SUBJECT PROJECT CONCEPT REPORT APPROVAL - BRIDGES AT PETIT CREEK AND ETOWAH OVERFLOWS

FILE	BHF-018-1(41) Bartow County P.I. No. 620830 TDM-2 Sufficiency Rating 61.6; 60.4; 60.2	OFFICE	Preconstruction
		DATE	March 31, 1987
FROM	Alton E. Crowe, Jr., Director of Preconstruction		
TO	Thomas D. Moreland, Commissioner		
SUBJECT	BRIDGE WIDENING AT PETTIT CREEK & BRIDGE REPLACEMENT AT ETOWAH OVERFLOWS - PROJECT CONCEPT REPORT

FILE BHF-018-1 (41) Bartow County  
P.I. No. 620830  
Bridge Widening over Pettit Creek/Bridge  
Replacements on Etowah River Overflows

SUBJECT PROJECT CONCEPT REPORT

TYPICAL SECTION - SITE 3

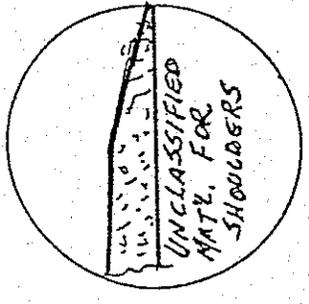
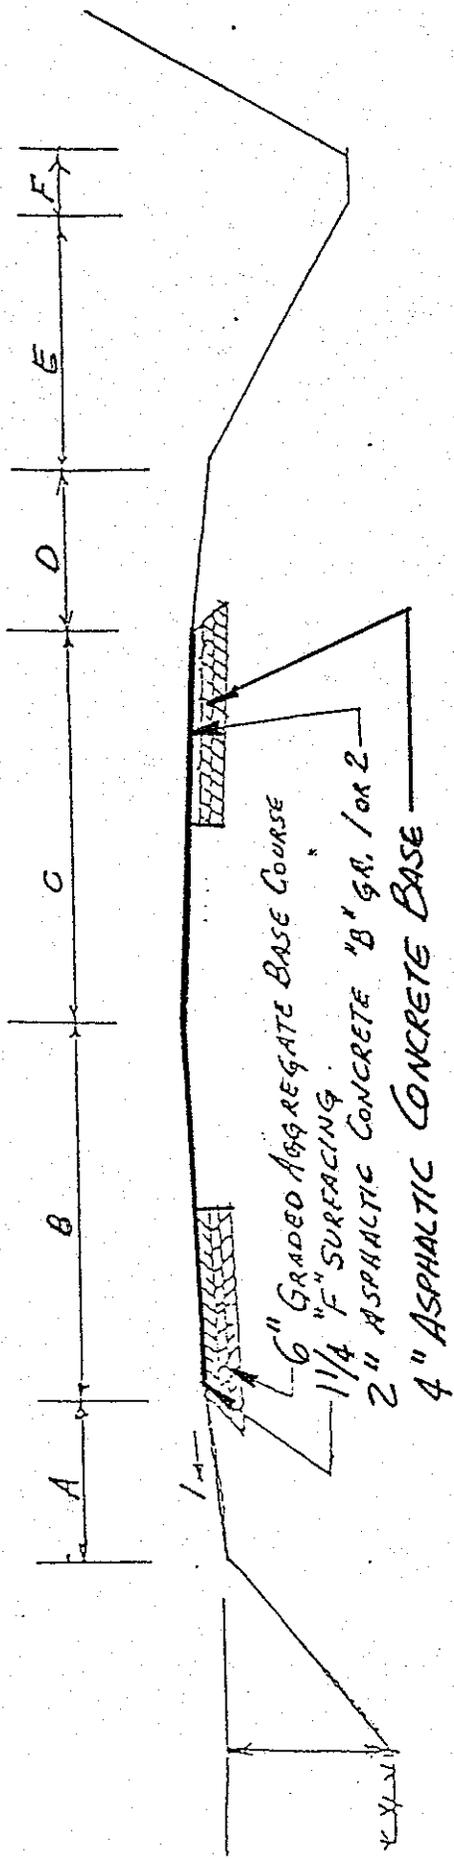
Widening the bridge over Pettit Creek to one side should be considered as an alternate to the proposed symmetrical widening.
